Arlington High School Building Committee
Finance Subcommittee Meeting
Thursday, July 18, 2024
Conducted by Remote Participation
4:00 PM – 4:30 PM
Agenda

7/18/24 AHSBC Finance Subcommittee Meeting Meeting Materials

1. Motion to approve Consigli's Change Order #42 for \$77,519.91
2. Motion to approve Consigli AHS Requisition #51 for \$2,334,539.70
3. Motion to approve HMFH Amendment #9 for \$36,135.00
4. Motion to approve Budget Revision Request #7

Snippet- Phase 1 Site plan E4.1.1

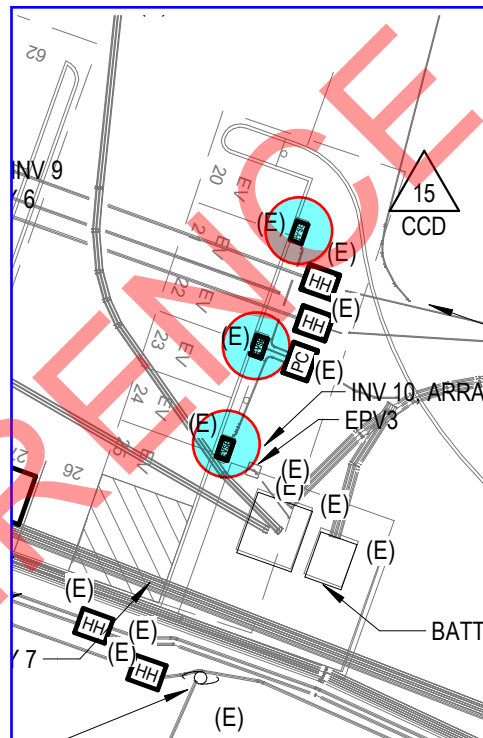
CR279.1 includes costs associated with CCD-035 - Provide EV Charging Stations dated 12/2/21 issued by HMFH. Per CCD-035, (2) stations to be furnished at Schouler Ct. (Phase 1), and (3) at West Lot (Phase 3-4). CR279.1 includes pricing associated with the furnish of (3) Stations at Phase 3/4 locations only. Furnish of Ph. 1 stations, as well as installation, wiring, and associated electrical work for Phase 1, and 3/4 locations was previously approved under CR279. Please see attached pricing and associated backup for additional information.

Attachments:	Product data sheet for Charging Stations to be provided. Partial E4.1.1 and E4.4.1 for locations of stations to be provided.	
distribution:	<input checked="" type="checkbox"/> Owner – Adam Chapdelaine	<input checked="" type="checkbox"/> Architect – Arthur Duffy, Lori Cowles
	<input checked="" type="checkbox"/> OPM – J Burrows, Sy Nguyen, H. Raymond	<input checked="" type="checkbox"/> Contractor – J. LaMarre, C. Weber, D. Dockendorf
	<input checked="" type="checkbox"/> Consultant – Bala,	<input checked="" type="checkbox"/> Field – C. McWilliams, T. DeRosa

Stations to be priced/procured just prior to time of Phase 4 install.

E 3.0a
Vestibule V1-04

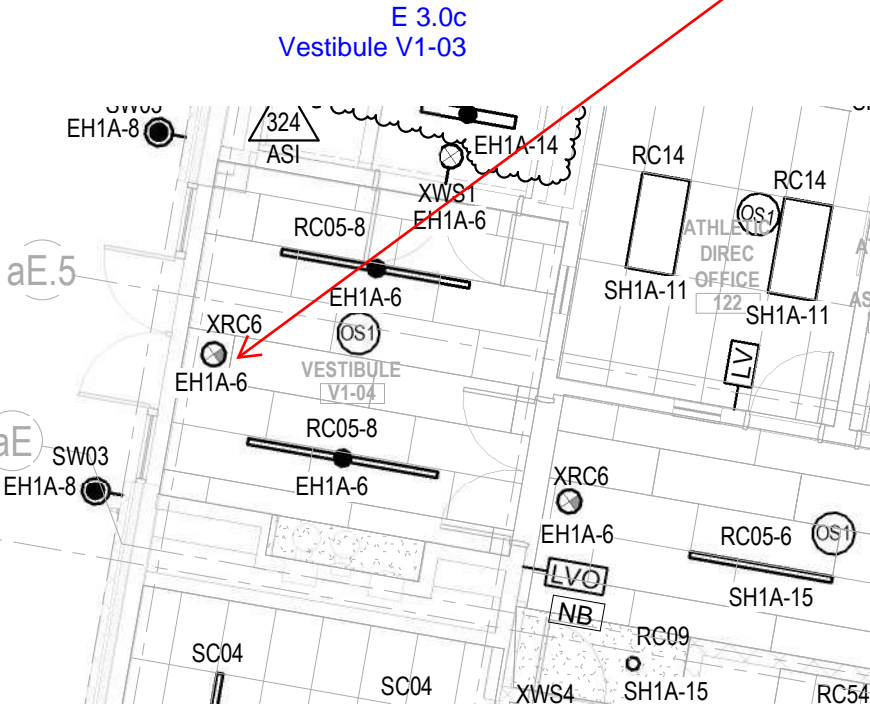
The exit signs scheduled for V1-03 (Part C) were scheduled as bottom mount mullion type; without the transoms at both vestibule door locations they are not installable.

This XWS9 to be re-ordered as wall mount type (see attached)

PRE-K CLASSROOM - P2-01 (WEST) / TYP TEACHING WALL

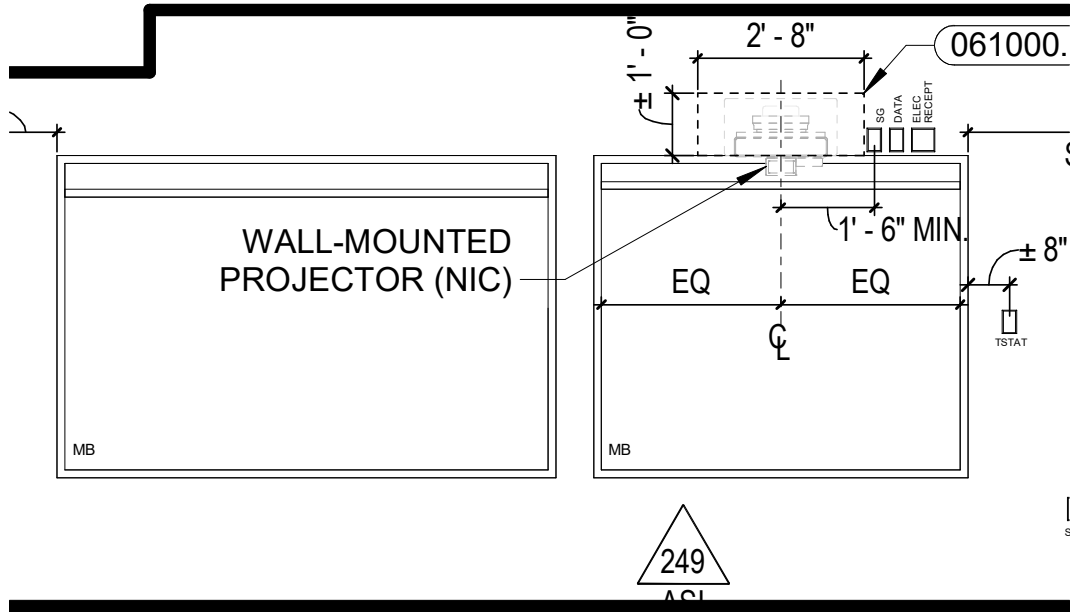
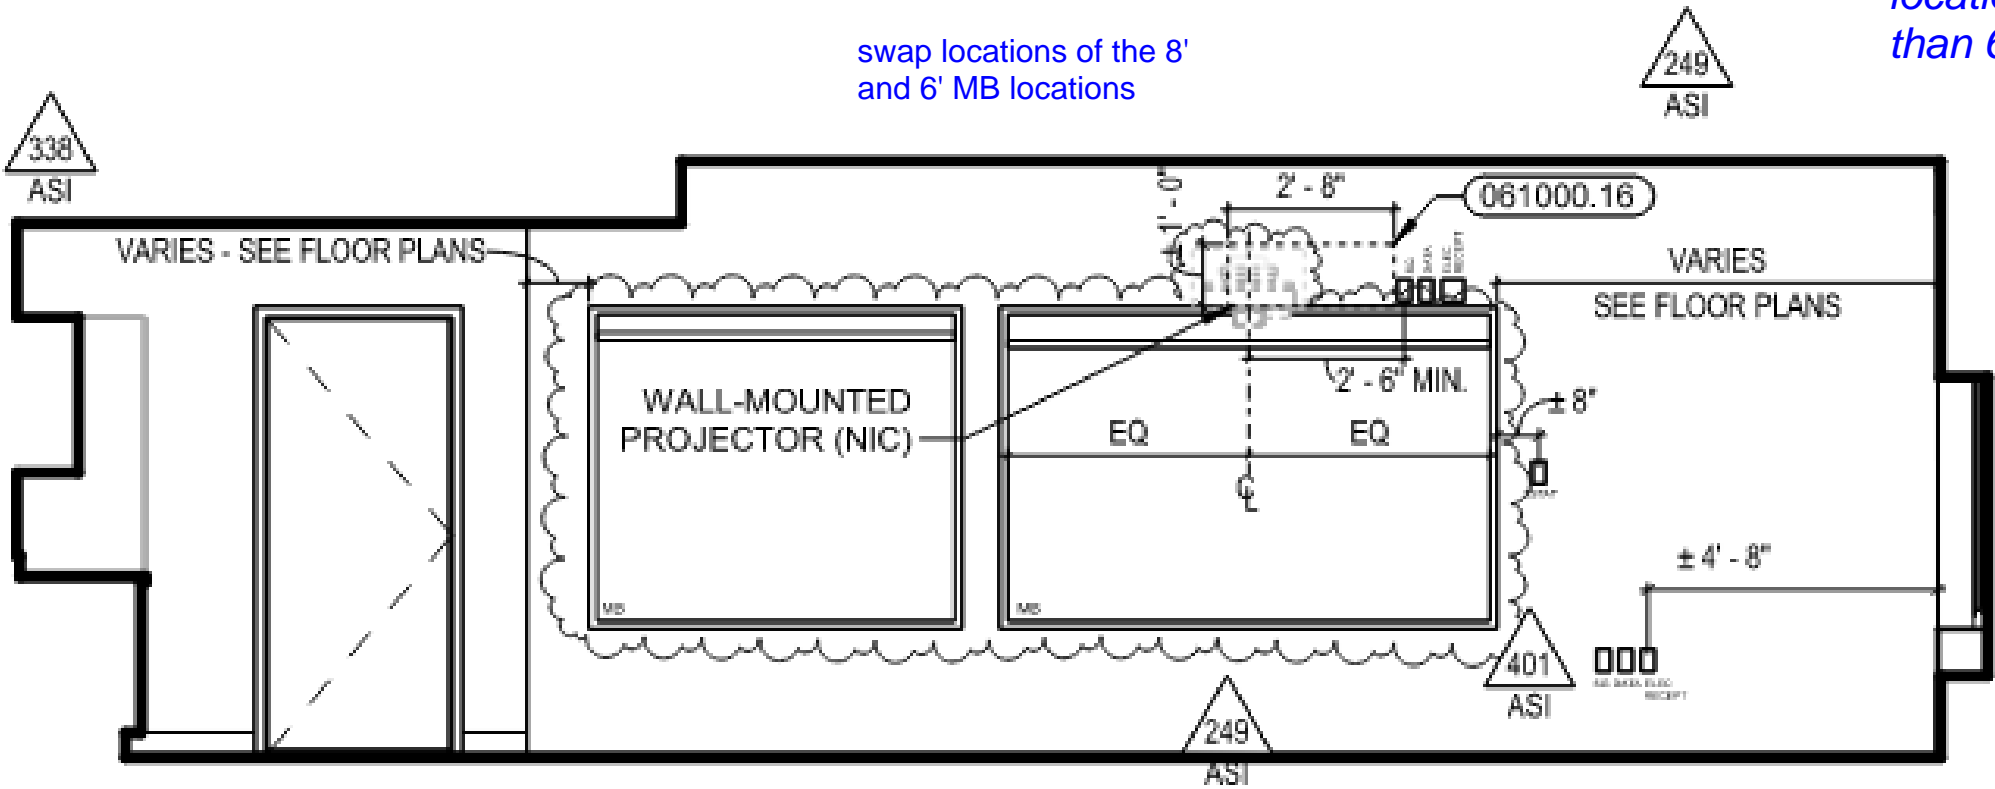
PreSchool Classroom P.201 west wall: swap the (installed) locations of the 8' and 6' markerboards. This required to optimize the Technology procured installation/function of the short throw projector (which has an image projection ration that works best with an 8' board.
See attached sketch SKA-308.

ASI-401.1: CR P.101: shift location of MB to accomodate IWB.

ASI-401.1: Lower MB in P.212 to be 2'-2" AFF.

note- it has been communicated to CSS in field that Projector is to be mounted at location for 8' MB rather than 6'.

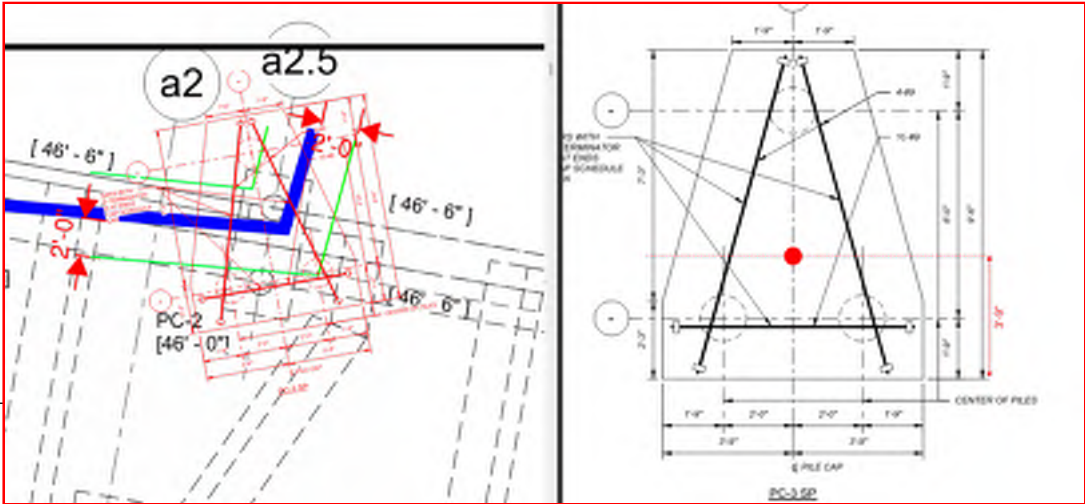
Confirming RFI (see attached email chain) that it is acceptable to switch the PC2 on aH/a2.5 line to a PC3-SP. This is to avoid conflict with the 8" active water main discovered in conflict with the prior shown location of PIF-2.

Confirmed. The PC-2 at aH-a2.5 can change to a PC-3 SP in order to avoid conflict with the existing 8" water main. Follow all dimensions shown on S3.3 for the PC-3 SP. The pile cap can be rotated, but the grid intersection / column centerline needs to be at the centroid of the pile cap as shown by the red dot in the image below.

PHASE-3 / PART-A / PILE CAP PLAN
SCALE: 1/8" = 1' - 0"

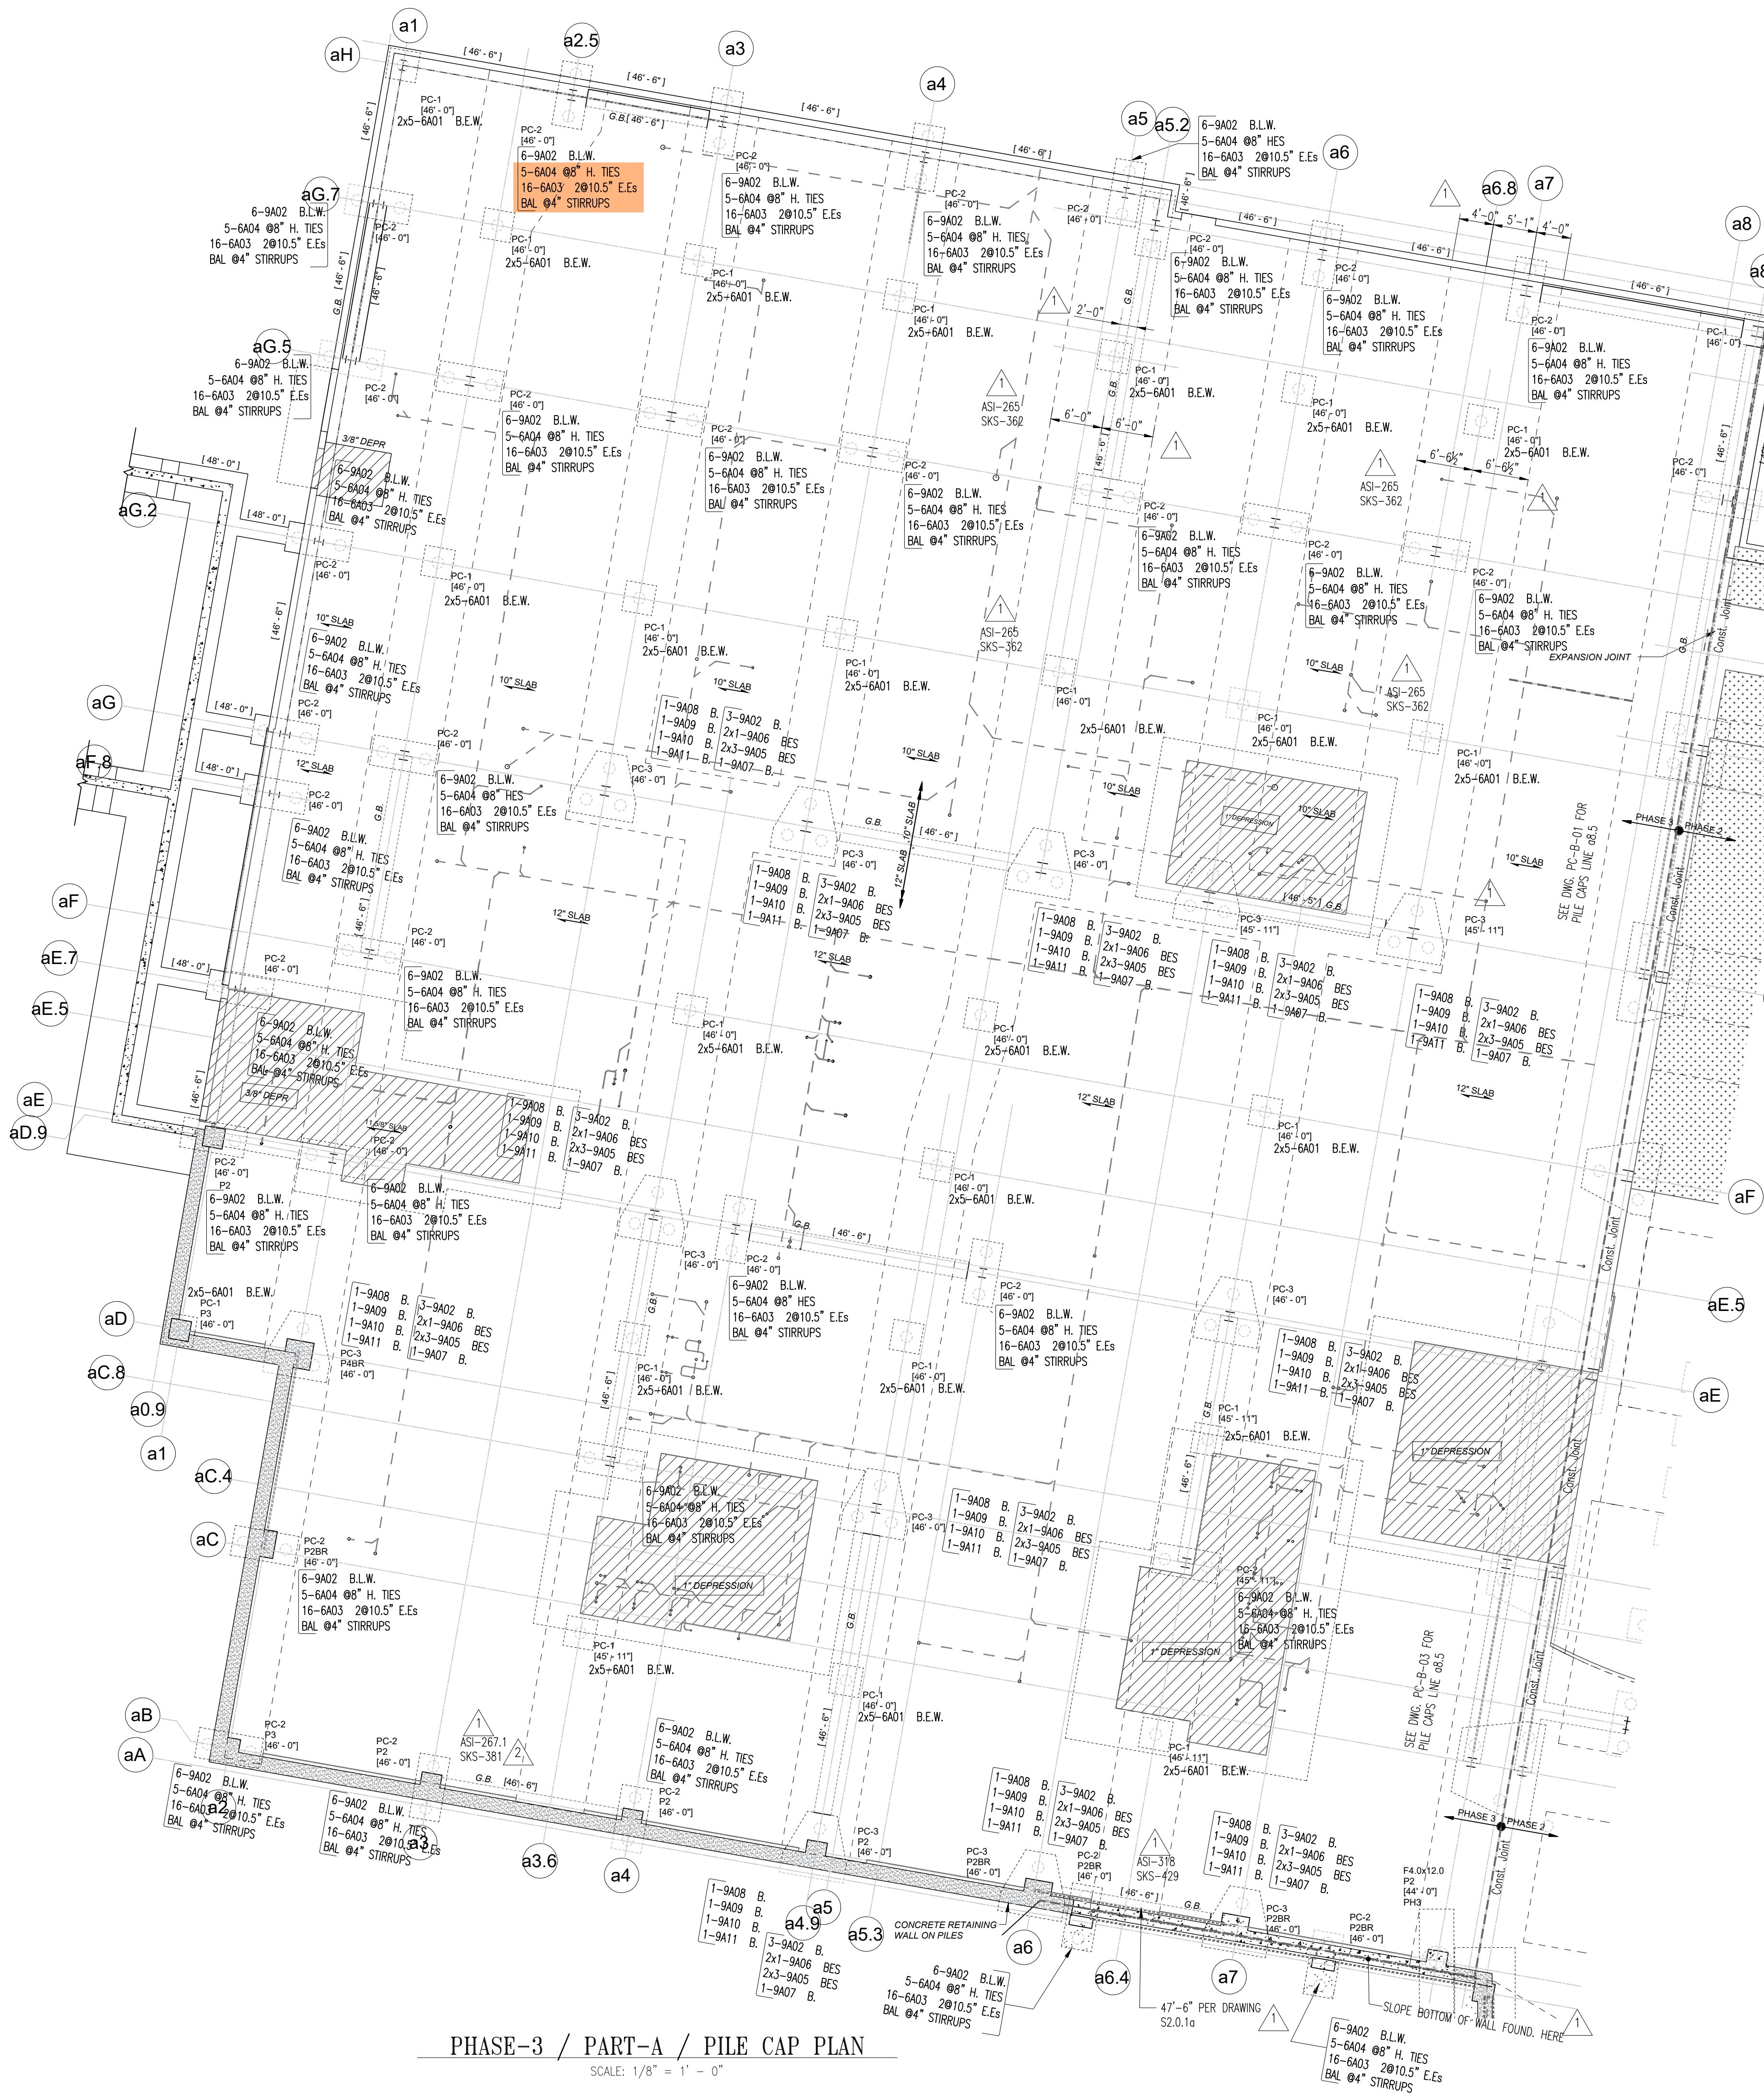
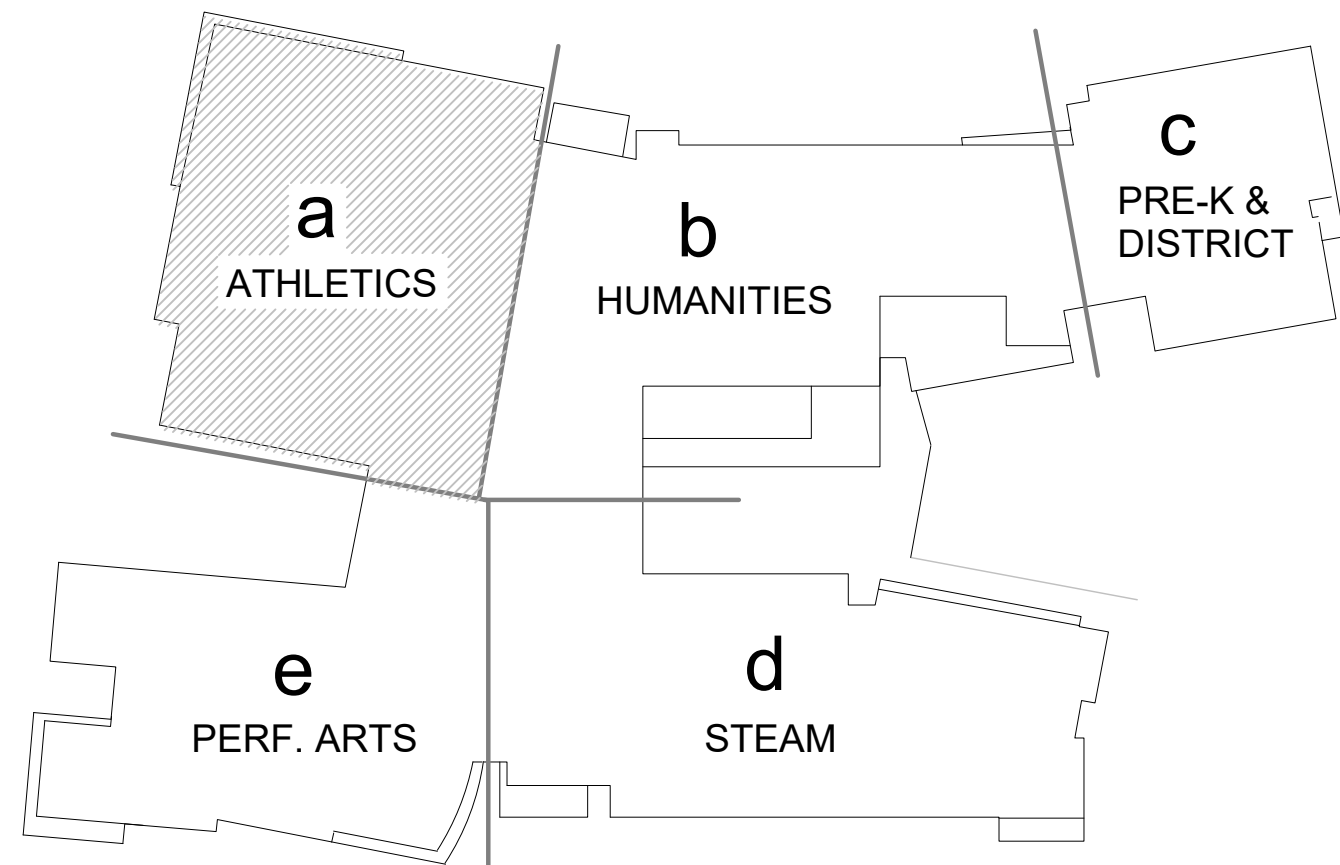
EXPLANATION: Change the pile cap at line aH/a2.5 from type PC-2 to type PC-3 SP
The change includes detailing PC-3 SP and extra dowels+A56
Releases #8015-1T & #8016-2

1 TOILET FACILITY BUILDING PART PLAN
1/4" = 1'-0"

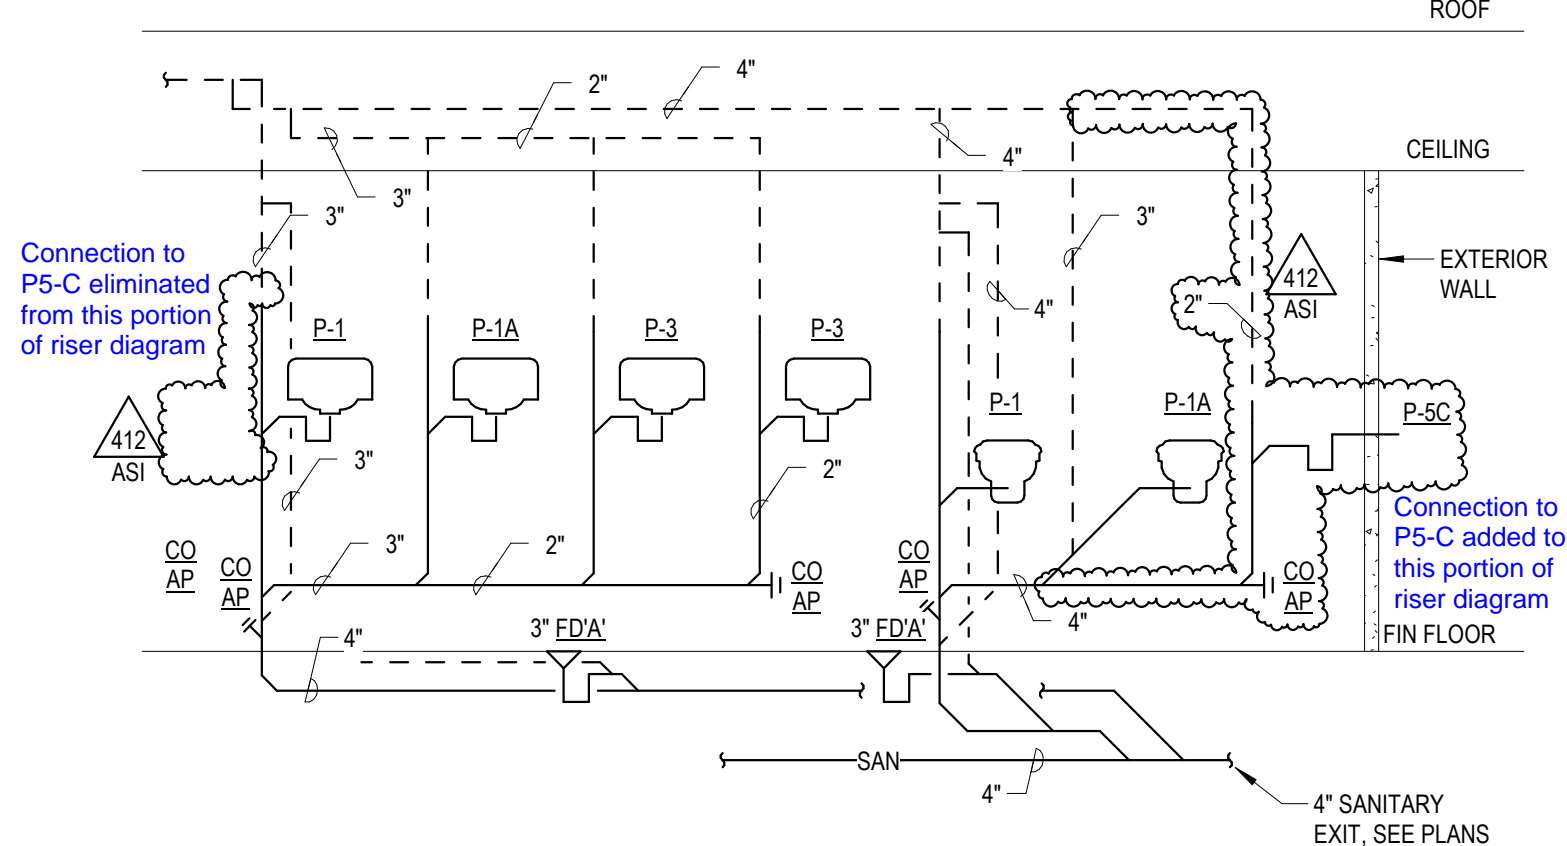
Plumbing: Revise exterior wall mount DF fixture to be Bottle-Filling station fixture. Shift location from south side/west wall to north side/west wall. *Note: this plumbing fixture had not yet been submitted for review/approval.* **See sketch SKP-43.**

Change of model to be Bottle-filling station rather than DF
(note: no submittal had yet been made for this fixture)
